AMENDMENTS TO THE SUBSTITUTE SPECIFICATION:

AMENDMENTS TO THE DRAWINGS:

FIG. 4

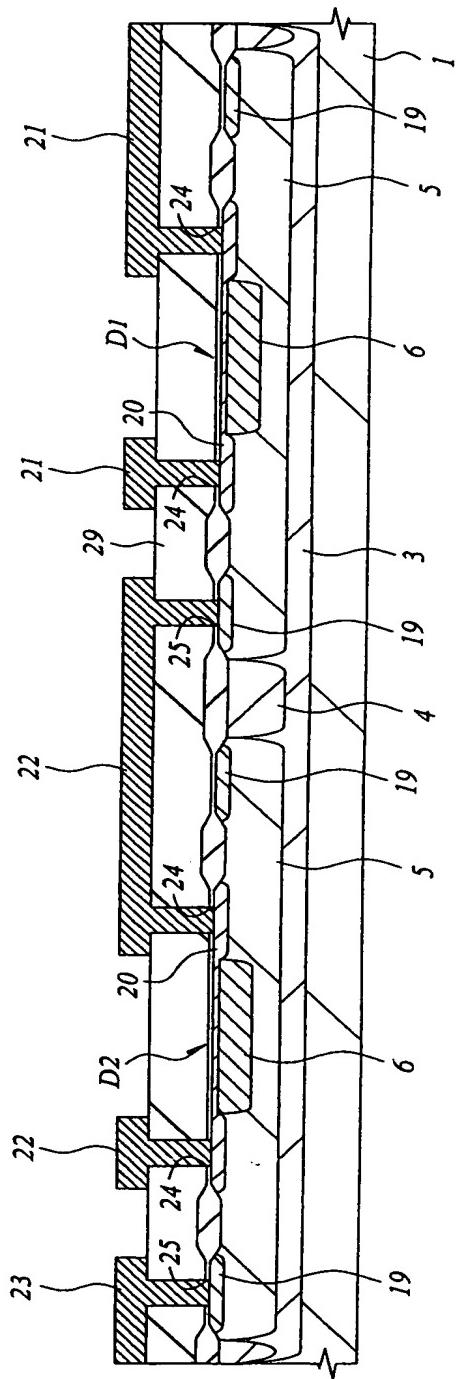
The attached sheet of drawings includes the earlier approved changes to Fig. 4. This sheet, which includes Fig. 4, replaces the originally submitted drawing sheet of that Figure. In Fig. 4 a labeling correction of the third contact hole from the left in that Figure was effected.

The accompanying replacement sheet of drawings directed to Fig. 4 thereof formally includes the earlier revision proposed in the paper submitted on January 21, 2003, which was approved for entry in form PTO-326 in connection with the Final Office Action dated April 8, 2003. Acceptance and formal entry therefor of the same is respectfully requested.
